**RE: Response to Adequacy Review No. 2, 112c Construction Materials Permit Application  
Section 25 Sand Mine, Permit No. M-2025-015**

This letter addresses the *Adequacy Review* letter dated July 22, 2025 regarding the Section 25 Gravel Mine 112 Construction Materials Reclamation Permit Application Package. Responses to the Division's comments follow in **bold**:

# EXHIBIT C1

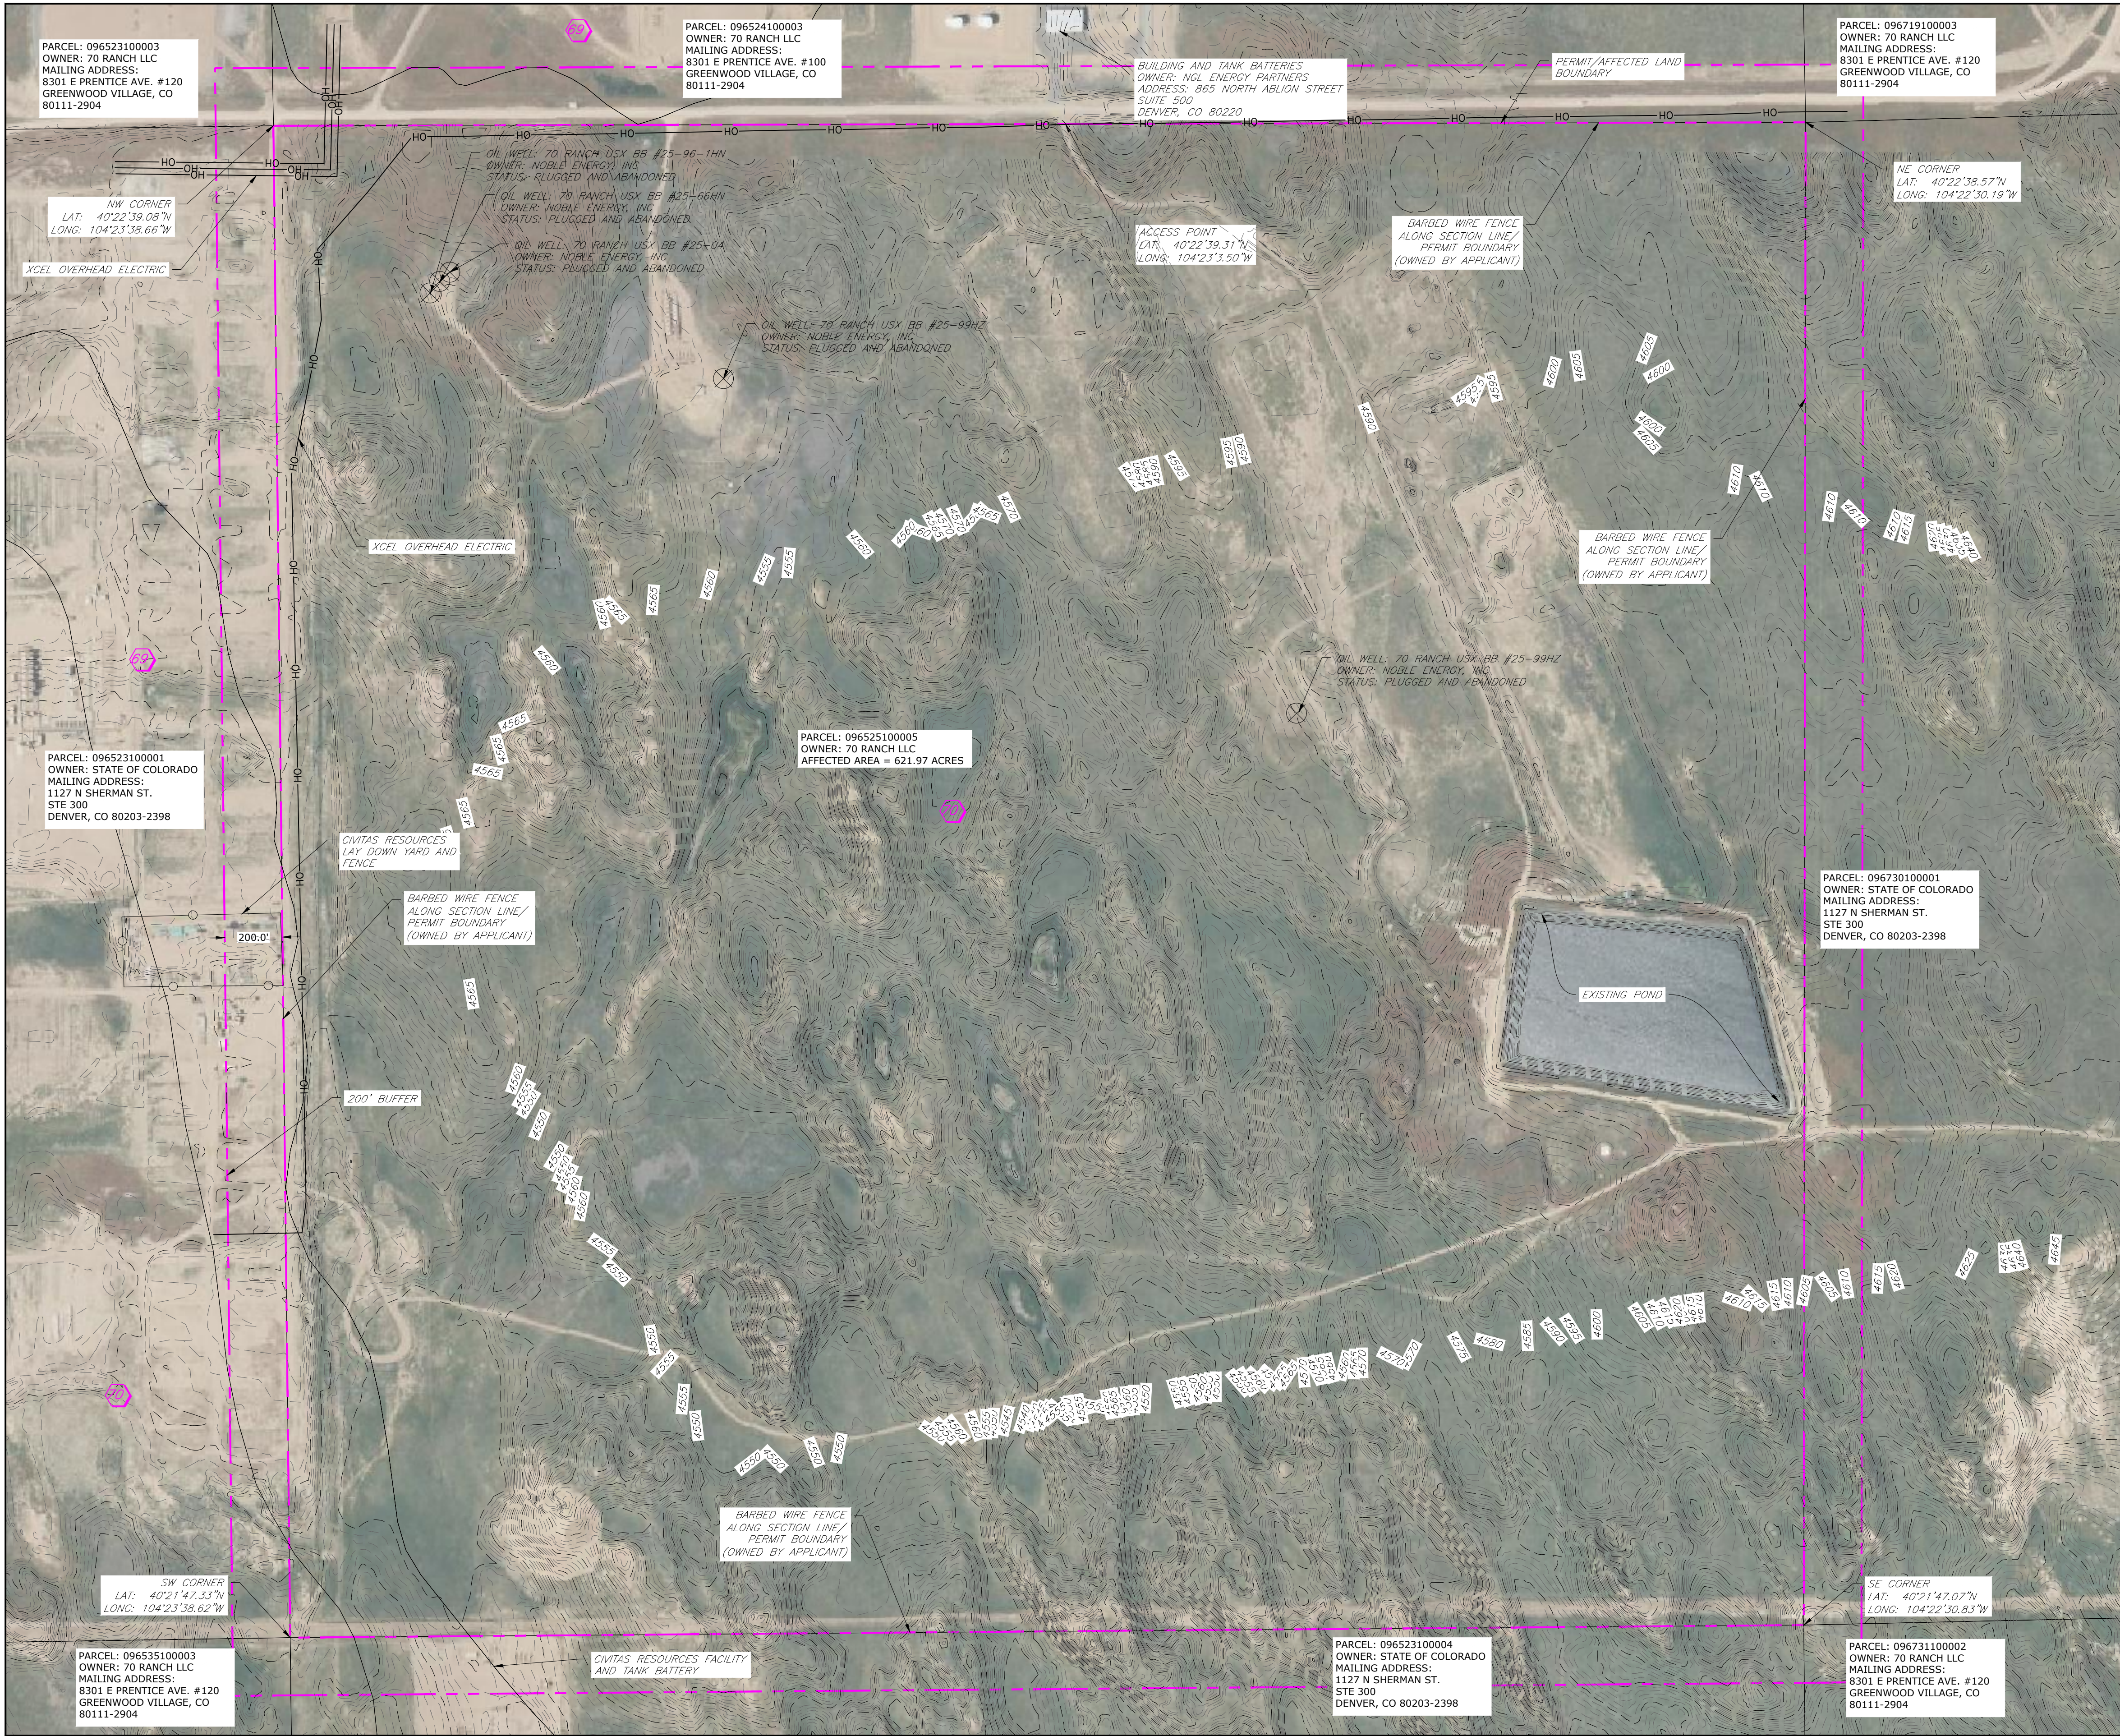
1. In the Division's item no. 1, of the June 4th letter, it requested the coordinates of the permit boundary corners. In response the Applicant provided a land survey plat of the permit area. The map provided indicates the permit boundary to be the section lines. The area of Lot 25 is stated to be 621.97 acres. The permit application is for 640 acres not 621.97 acres. Please clarify this discrepancy and provide the coordinates of the permit boundary corners.

**The permit application should be 621.97. All references to 640 have been changed to reflect the surveyed boundary. The lat/long coordinates have been provided for the permit boundary corners on map C-1.**

SHEET:  
C-2

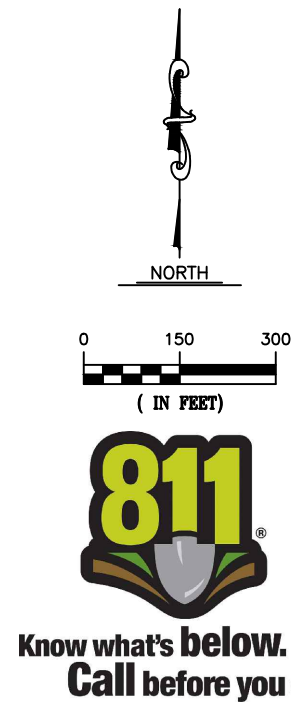
2. In response to Division's item no. 3 the Applicant stated that the existing infiltration ponds will be mined down another 5 feet. Is the applicant referring to the lined pond? If so, please update Figure C-2 to adjust the mine limit boundary to include the pond and update the narrative of Mining Plan to clearly indicate mining of the pond. If the pond is included does that increase the total mine acreage of 396 acres?

If the Applicant is referring to infiltration ponds that will be installed as part of the processing plant, please show their general location as part of the processing plant. The Division cannot locate within the Mining Plan, where it discusses mining down of the infiltration ponds, please update.

4. In the Earthmoving subsection there is a reference to Figure C-6, please revise with the correct figure.

**The infiltration ponds on the property are to the south of the mine cell. There was internal discussion about mining out the bottom of these ponds to increase functionality but it was later dropped. The mention of mining this area should have been removed from the item 3 response. Please disregard.**

**Corrected to refer to C-2.**
